# Imray Correction Notice

ICC52-2

## Chart C52 WGS 84

Edition 2015

**34 Holyhead (Plan C)**

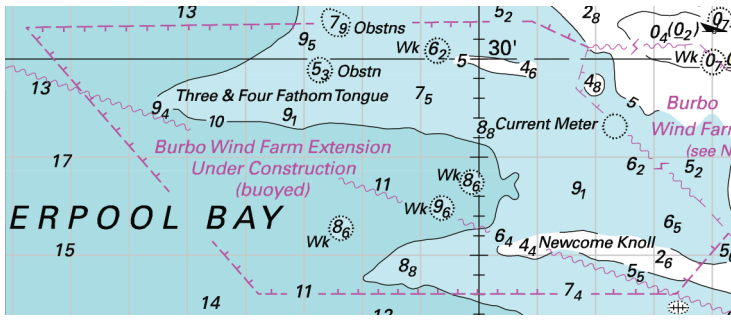
Holyhead Marina has suffered extensive storm damage and there are numerous obstructions in the area. The jetties are being reconstructed.

Delete Lt 2F.R(vert) in 53°19'·32N 4°38'·64W.

Yachtsmen are advised to contact the local Harbour Authority for further information. (ILNW 596/18)

Block correction for C52  
ILNW 183/16

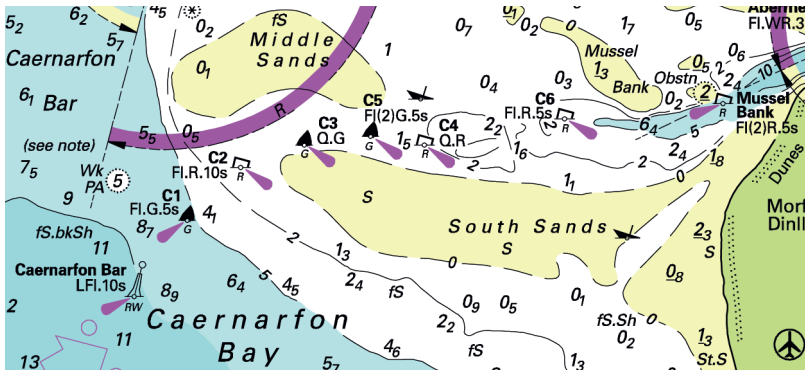
Insert accompanying block correction centred on 53°28'·97N 3°16'·89W. (ILNW 183/16)
